DEVELOPMENT APPLICATION ASSESSMENT REPORT

Application Number:	DA2023/0379
----------------------------	-------------

Responsible Officer:	Jordan Howard
Land to be developed (Address):	Lot 18 DP 19022, 107 Iris Street BEACON HILL NSW 2100
Proposed Development:	Torrens title Subdivision of one lot into four lots
Zoning:	Warringah LEP2011 - Land zoned R2 Low Density Residential
Development Permissible:	Yes
Existing Use Rights:	No
Consent Authority:	Northern Beaches Council
Delegation Level:	NBLPP
Land and Environment Court Action:	No
Owner:	Michael Benedict Hayes Maree Smaragdi Jaloussis
Applicant:	Maree Smaragdi Jaloussis

Figure 1 - Proposed Subdivision Plan with access driveway excluded from lot size calculation in red.

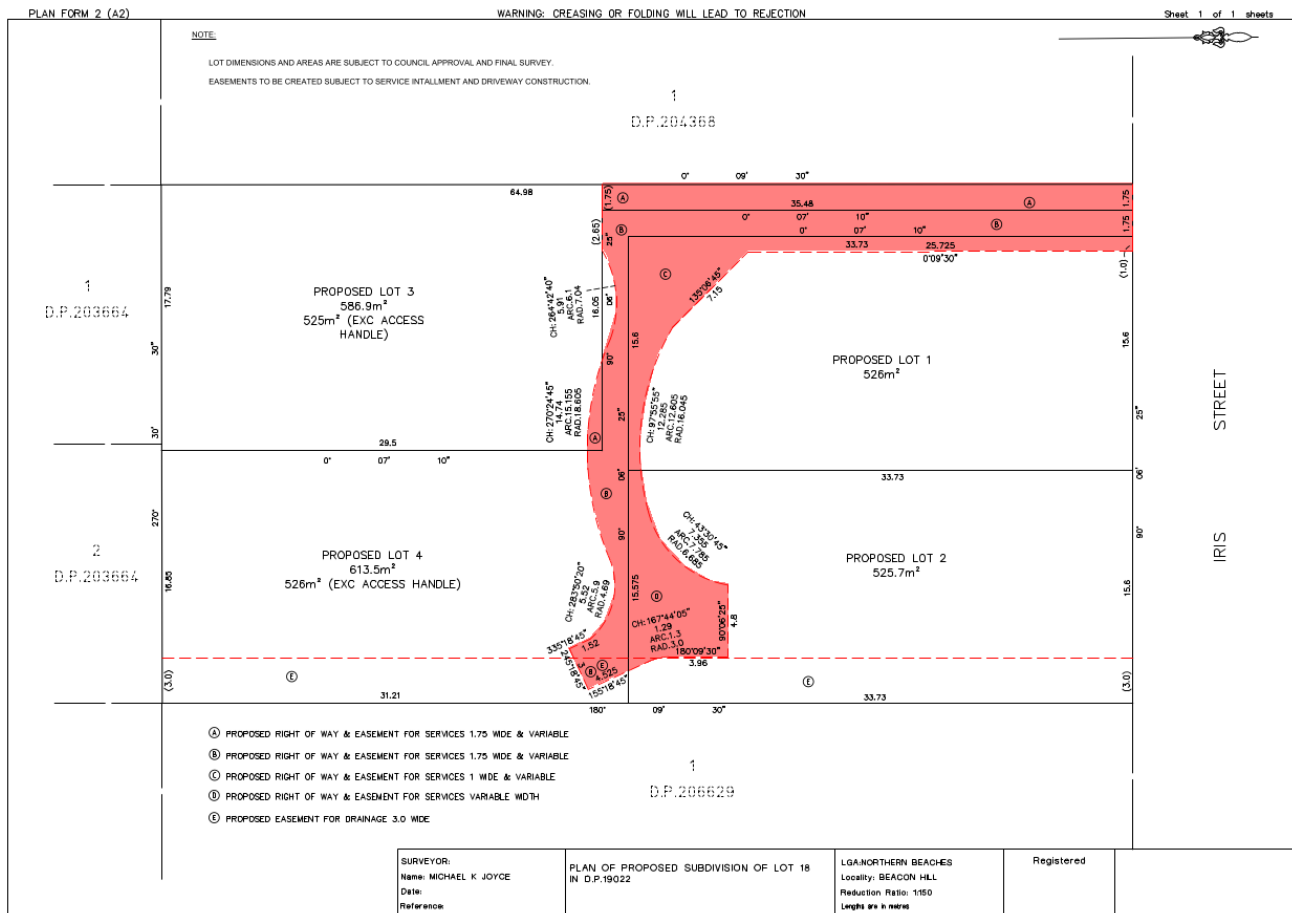
However, these figures did not accurately reflect lot size, as all right of carriageways and access ways were not excluded in accordance with the Clause, rather just the drawn access handles of the rear lots were excluded. All areas of the access driveway are required be excluded. *Figure 1* shows in red the access driveway excluded from lot size calculations. The driveway, covered by right of way & easements, is larger than the drawn access handles for Lot 3 & 4, and encroaches into Lot 1 & 2. As such, the actual lot sizes are smaller for all allotments.

Therefore, in accordance with the method of calculation outline by this Clause, the following lot sizes are proposed and assessed in this report:

- Lot 1: 451.5sqm (excluding access) - a variation of 24.8%
- Lot 2: 475.8sqm (excluding access) - a variation of 20.7%
- Lot 3: 520.7sqm (excluding access) - a variation of 13.2%
- Lot 4: 493.6sqm (excluding access) - a variation of 17.7%

The applicant was notified of this discrepancy and additional information was provided . A revised written 4.6 request was provided seeking to justify the proposed variations, which is assessed in the section of this report on WLEP 2011 Clause 4.6 Exceptions to development standards.
